ECE/TRANS/WP.29/GRSP/2009/19
23 September 2009

REGULATION No. 29
(Cabs of commercial vehicles)

Proposal for the 03 series of amendments to Regulation No. 29

Submitted by the secretary of the Cab Strength Informal Group */

Fig. 1 – Front impact test (test A).

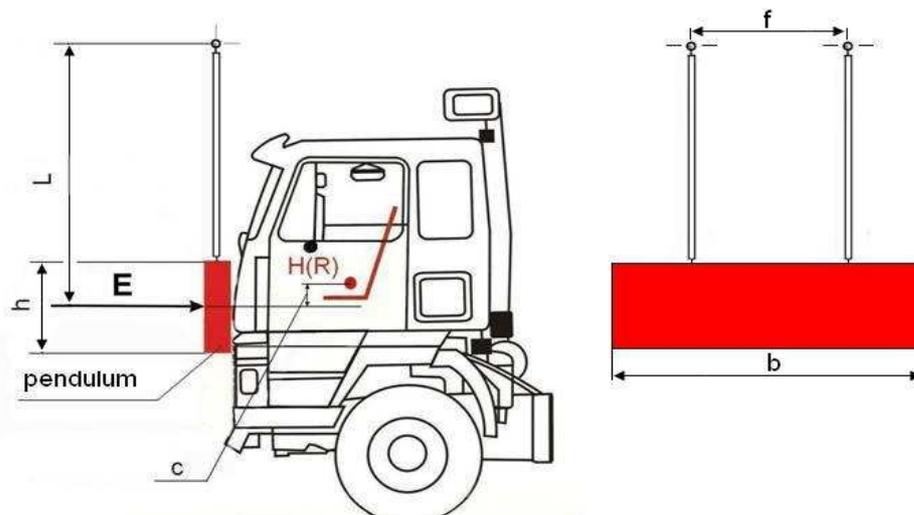
- 5.1. The **impactor swing-bob** shall be made of steel and its mass shall be evenly-distributed; its mass shall **not be less than 1,500 ± 250 kg**. Its striking surface, rectangular and flat, shall be 2,500 mm wide and 800 mm high (see **b and h on Figure 1**). Its edges shall be rounded to a radius of curvature of ~~not less than 1.5~~ **mm 10 mm ± 5 mm**

- 5.2. The **impactor swing-bob** assembly shall be of rigid construction. The **impactor swing-bob** shall be freely suspended by two beams rigidly attached to it and spaced not less than 1,000 mm apart (see **f on Figure 1**). ~~The beams shall be of "I" section with a web height of not less than 100 mm or shall be of a section having at least an equivalent moment of inertia.~~ The beams shall be not less than 3,500 mm long from the axis of suspension to the geometric centre of the ~~bob~~ **impactor (L on Figure 1)**.

New Figure explaining the frontal impact test - Test A.

Fig. 2. – Front pillar impact test (Test B).

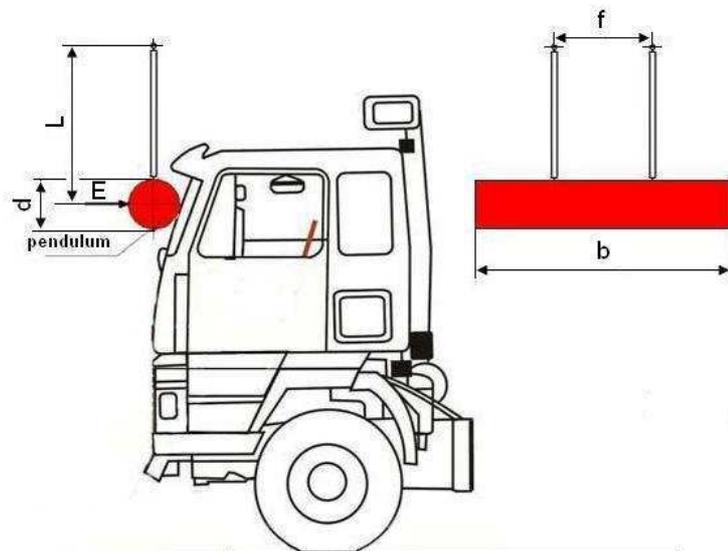
- 6.1. The impactor shall be rigid ~~be made of steel~~ and its mass shall be evenly-distributed; its mass shall not be less than 1,000 kg. The impactor shall be cylindrical with a diameter d of the cylinder of 600 ± 50 mm and a length b of not less than 2,500 mm. Its edges shall be rounded to a radius of curvature of not less than ~~15~~1.5 mm.

New Test B, including figure 2.

Suggestion to delete specification on material (steel): it is sufficient to specify that the impactor must be rigid.

Taking into account the commercial availability of such impactors, it is suggested to add a tolerance of ± 50 mm.

Fig. 3. Roof strength test (Test C).

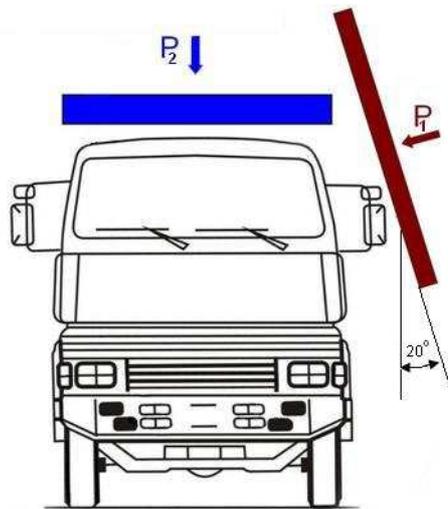
- 7.3.5. The impact energy shall be minimum 17.6 kJ.**
- 7.4. Roof strength test (see P₂ on Figure 3)**
- 7.4.1. The loading device shall be made of steel and its mass shall be evenly distributed.**

New Test C, including figure 3.

Fig. 4. – Rear-wall strength test

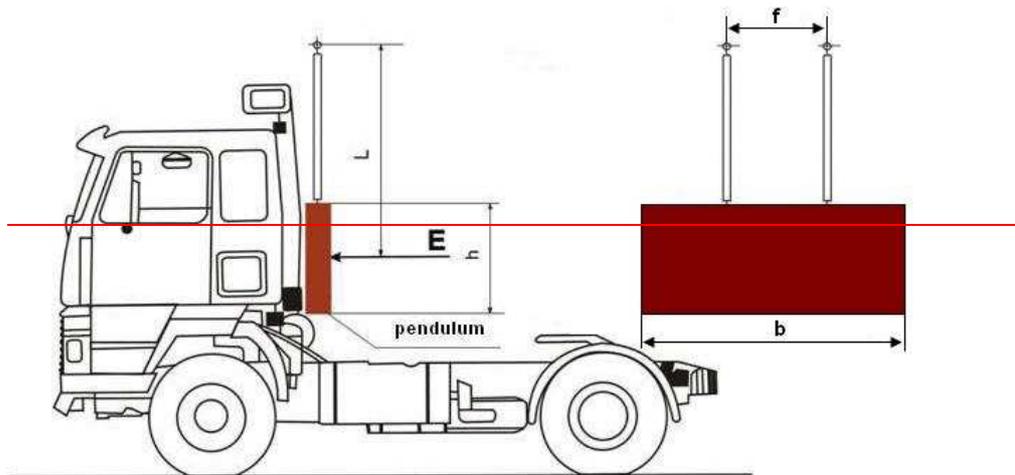
~~8.2. Vehicles of category N₂ with a gross vehicle mass exceeding 7.5 t and of category N₃ (see Figure 4)~~

Issue of test D must still be finalised, therefore square brackets were added.
